HISTORIC AND DESIGN REVIEW COMMISSION

February 05, 2020

HDRC CASE NO: 2020-034
ADDRESS: 1115 NOLAN
LEGAL DESCRIPTION: NCB 1665 BLK 1 17 & W 25 FT OF 16
ZONING: R-6 CD, H
CITY COUNCIL DIST.: 2
DISTRICT: Dignowity Hill Historic District
APPLICANT: Christopher Mongeon/MONGEON CHRISTOPHER &
OWNER: Christopher Mongeon/MONGEON CHRISTOPHER &
TYPE OF WORK: Construction of a 2-story, rear accessory structure and landscaping/hardscaping
APPLICATION RECEIVED: January 14, 2020
60-DAY REVIEW: March 14, 2020
CASE MANAGER: Edward Hall
REQUEST:

1115 Nolan Proposed Work for Backyard and New Structure

Site Plan

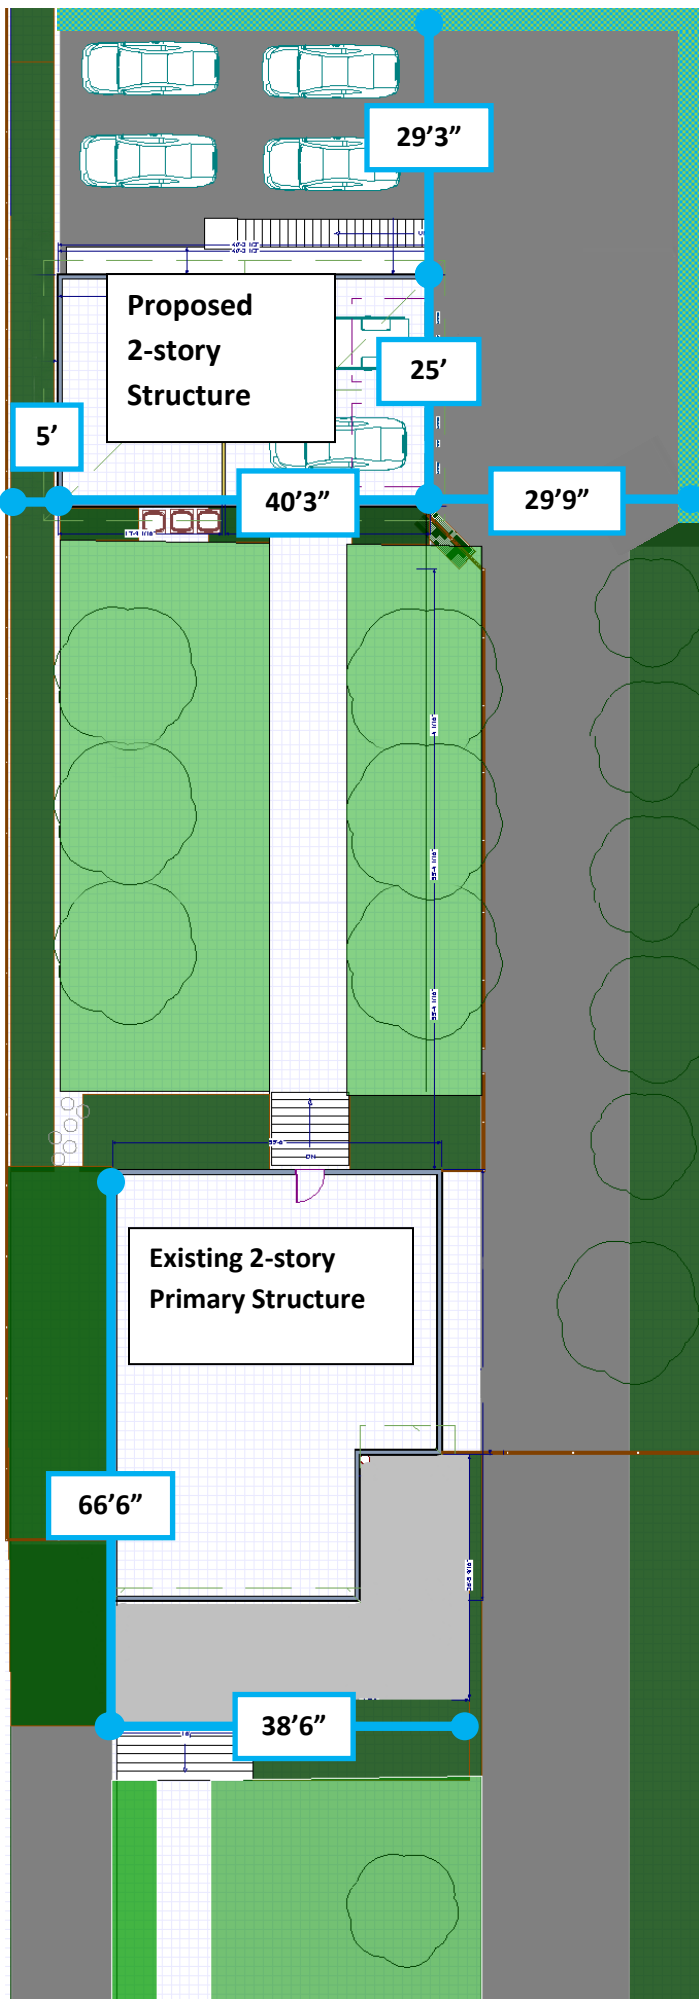
- d. BUILDING SIZE – The Guidelines for New Construction 5.A.ii. notes that new accessory structures should be no larger in plan than forty (40) percent of the primary historic structure’s footprint. Per the applicant’s provided site plan, the proposed structure’s footprint will exceed that which is recommended by the Guidelines. The applicant has proposed a footprint of approximately 1,000 square feet. This is not consistent with the Guidelines.

- e. SITE MATERIALS – The majority of the rear of the lot is currently covered in concrete paving. The applicant has proposed to reduce the existing amount of concrete paving by adding natural lawn areas between the primary historic structure and the proposed accessory structure. Since conceptual approval, the applicant has incorporated additional landscaping areas and buffers including a perimeter rain garden.

- k. SITE WORK – The property currently features a rear yard that is predominantly concrete. The applicant has proposed to remove portions of the existing concrete and install natural turf and landscaping areas. Staff finds the appropriate.

- l. REAR YARD PARKING – The Guidelines for Site Elements 7.A.i. notes that the preferred location for on-site parking is at the rear of the site, behind the primary historic structure. The applicant has proposed to locate parking for five (5) automobiles to the rear of both the primary structure and the proposed accessory structure. Staff finds this location appropriate. Per application documents, the applicant has noted additional parking locations along the driveway. The applicant has noted that the existing driveway and curbcuts will not be altered.

East Facing Elevation

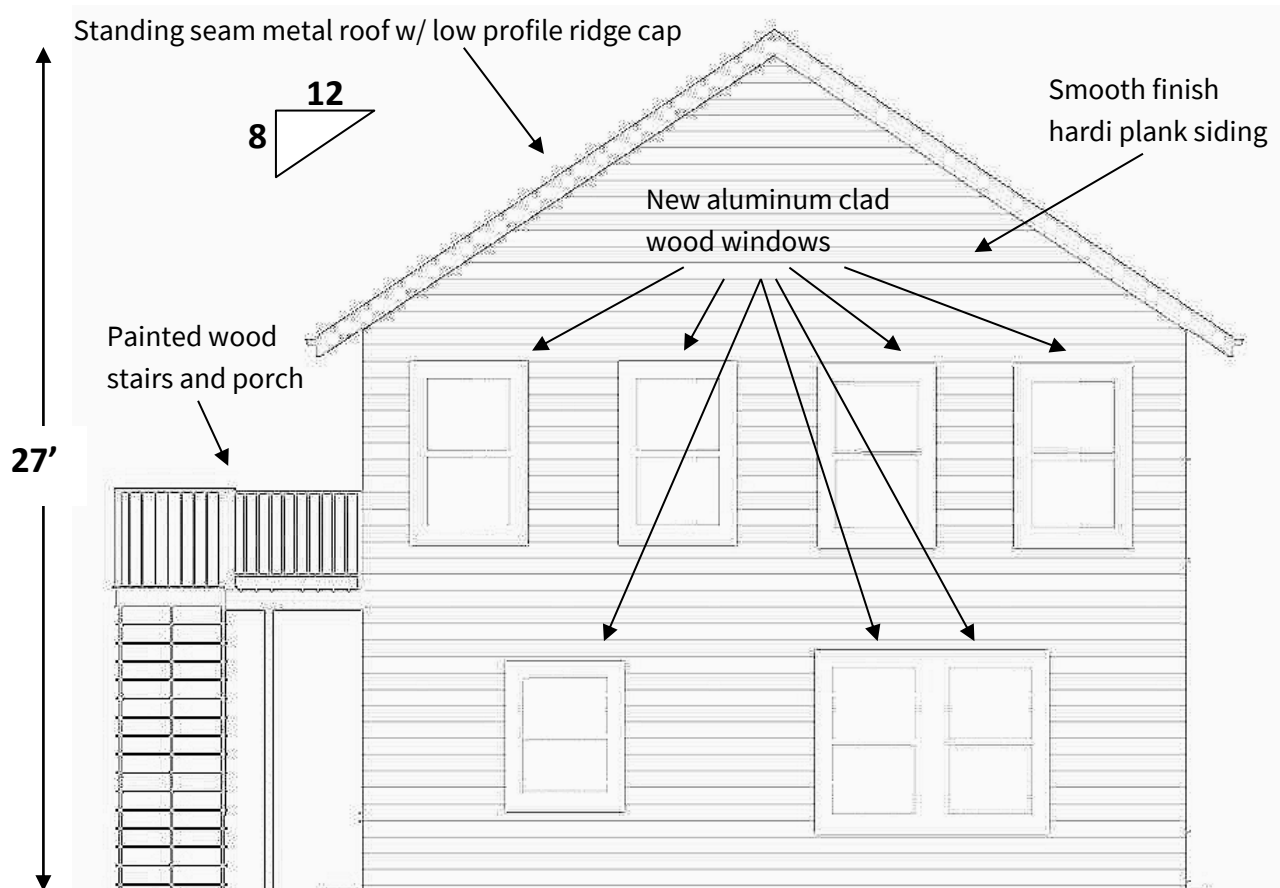
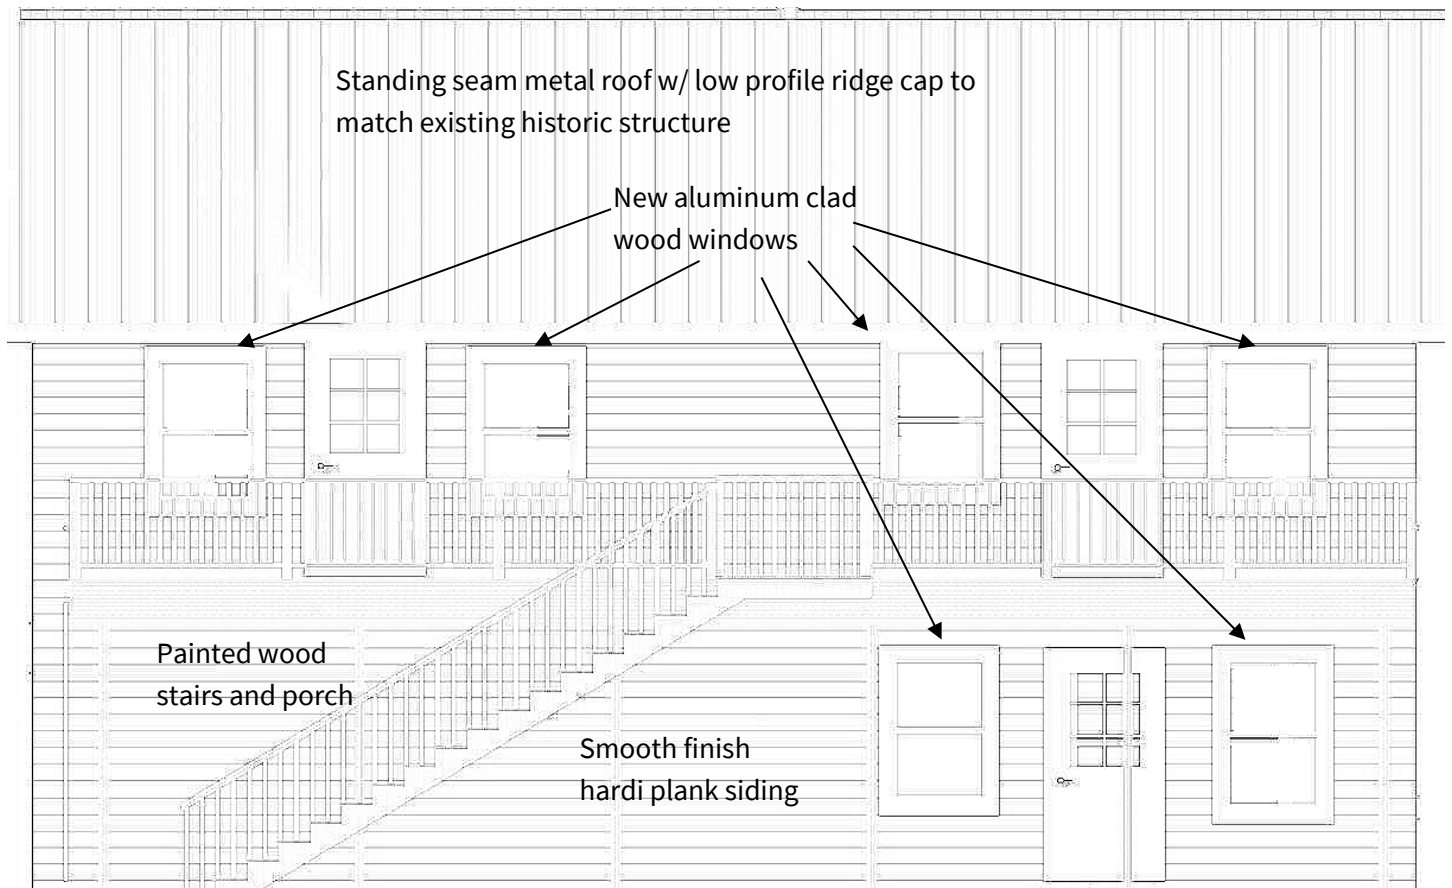
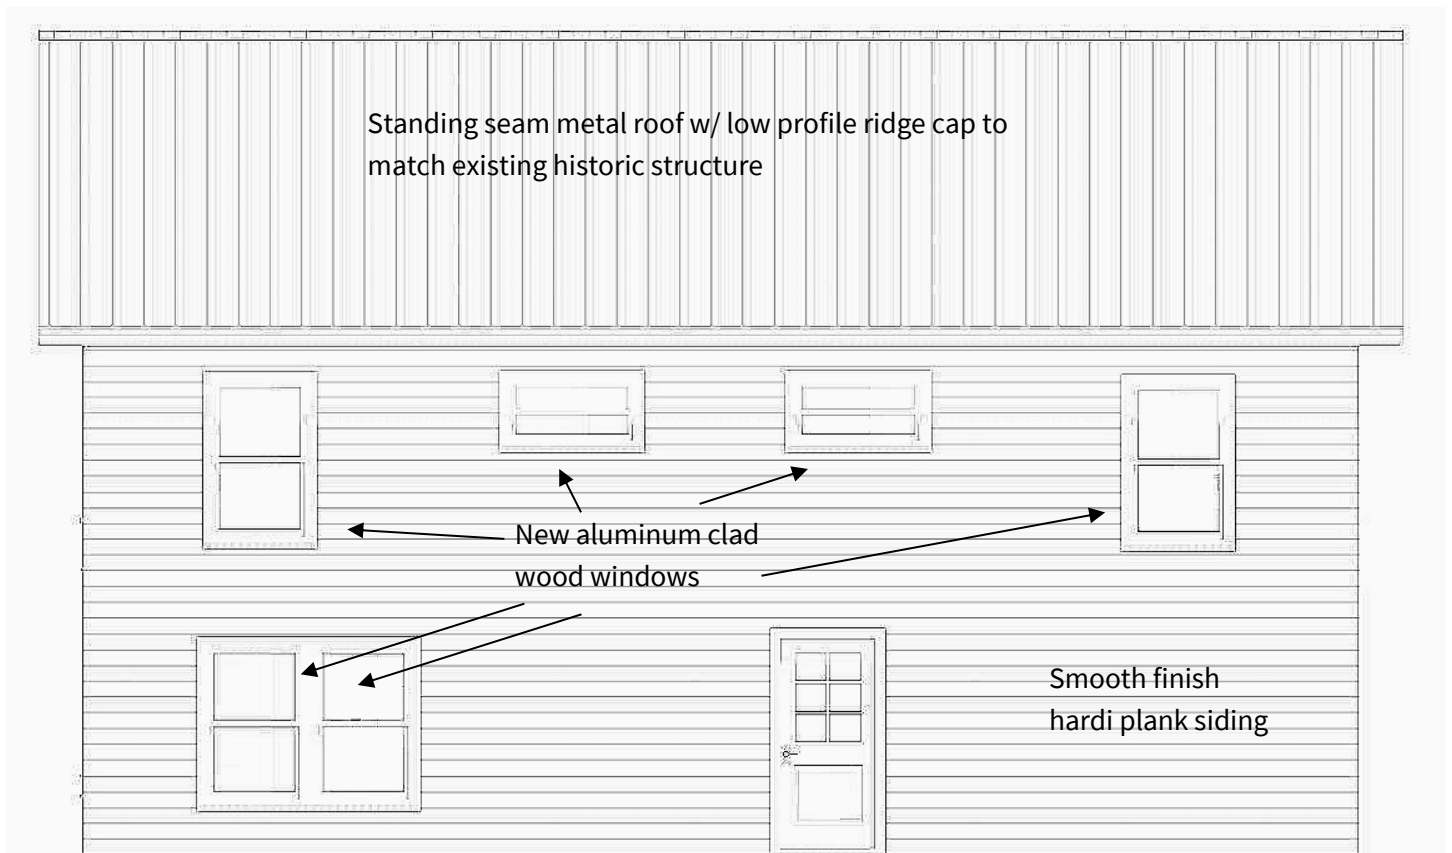
- c. MASSING & FORM – Per the Guidelines for New Construction 5.A.i., new garages and outbuildings should be visually subordinate to the primary historic structure on the lot in terms of their height, massing and form. The applicant has noted an overall height of twenty-seven (27) feet. The primary historic structure features an overall height of thirty-seven (37) feet. Double height accessory structures are not common in the Dignowity Hill Historic District. Staff finds that the construction of a two story rear accessory structure may be appropriate provided that the applicant explore ways of minimizing massing and height to the greatest extent possible. The proposed accessory structure should not be dissimilar to those found historically in the district.

- f. MATERIALS – The applicant has proposed materials which include Hardi board siding, aluminum clad wood windows, a standing seam metal roof and wood stairs and porches. The proposed standing seam metal roof should features panels that are 18 to 21 inches wide, seams that are 1 to 2 inches in height, a crimped ridge seam and a standard galvalume finish. A ridge cap should not be used. All Hardi siding should feature a smooth finish and an exposure of four (4) inches and a thickness of ¾”. Staff finds the proposed wood stairs and porches appropriate.

- i. That all window specifications be adhered to as noted in finding g.
- ii. That the proposed standing seam metal roof feature panels that are 18 to 21 inches in width, seams that are 1 to 2 inches in height, a crimped ridge seam and a standard galvalume finish.
- iii. That all Hardi siding feature an exposure of four (4) inches, ¾” thickness and a smooth finish.
